Orla Jones, 95 Connaught Street, Phibsborough, D07X998

**Re: CPO: Blanchardstown Bus Corridor, Case Reference: KA29N.313961**

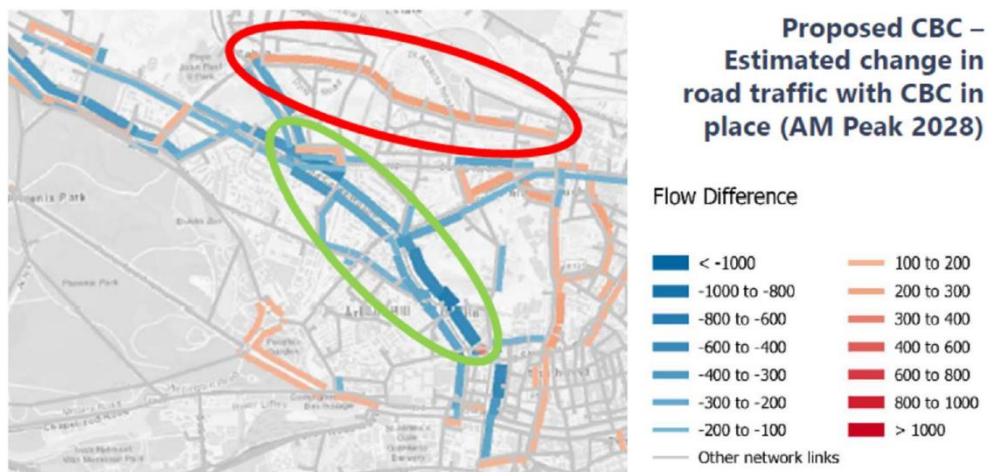
There are three road restriction changes proposed in the CPO application for the Blanchardstown Bus Corridor, none of which were set out in any of the proposed designs issued for public consultation since the Bus Connects project commenced in 2018.

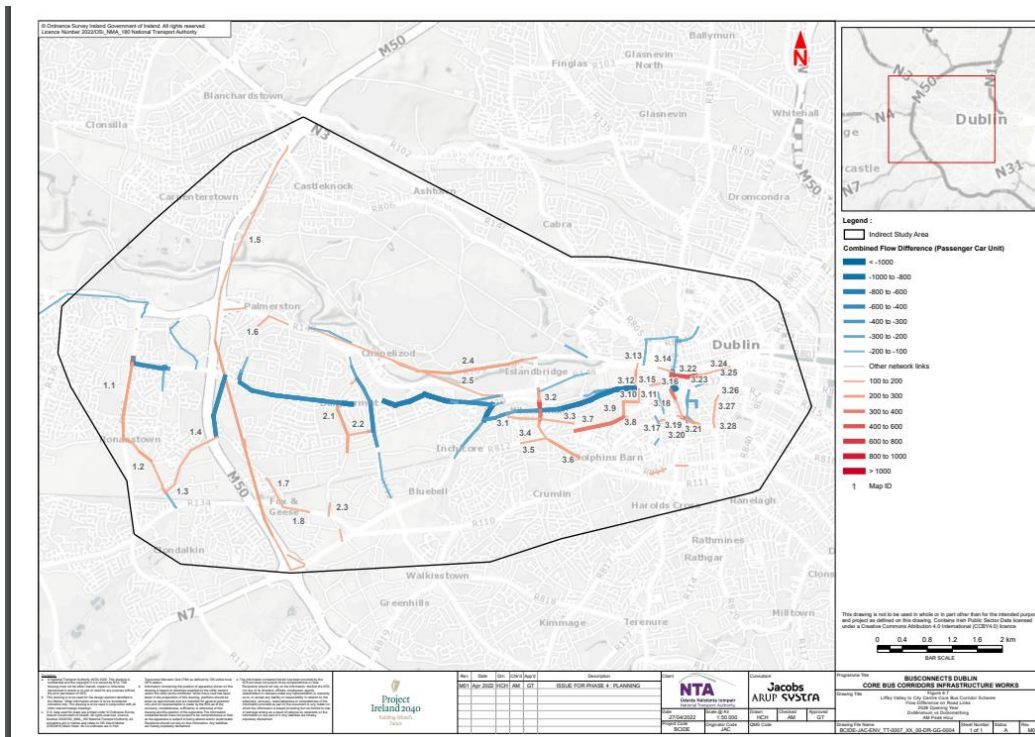
- **Flawed classification system of the impacts which sees areas forecast to experience an 80% increase in traffic flows being described as a “low impact” change.** In appendix A6.4 of the EIAR, Impact Assessments, the following are estimated when comparing a “Do Minimum” with a “Do Something” (i.e., BusConnects) scenario at PM peak hour:
  - An 80% increase in hourly traffic flows at the junction of Connaught Street and Shandon Crescent,
  - A 55% increase in hourly traffic flows at the junction of Fassaugh Ave and Dingle Road,

- A 64% increase in hourly traffic flows at the junction of Fassagh Ave and Bannow Road.

Each is described as having “not significant” effect and “negligible” impact. I can tell you as a resident of Connaught Street there is no way that changes of this nature can be considered “not significant” and “negligible” in their impacts on our abilities to go about our daily lives and live in a safe environment!
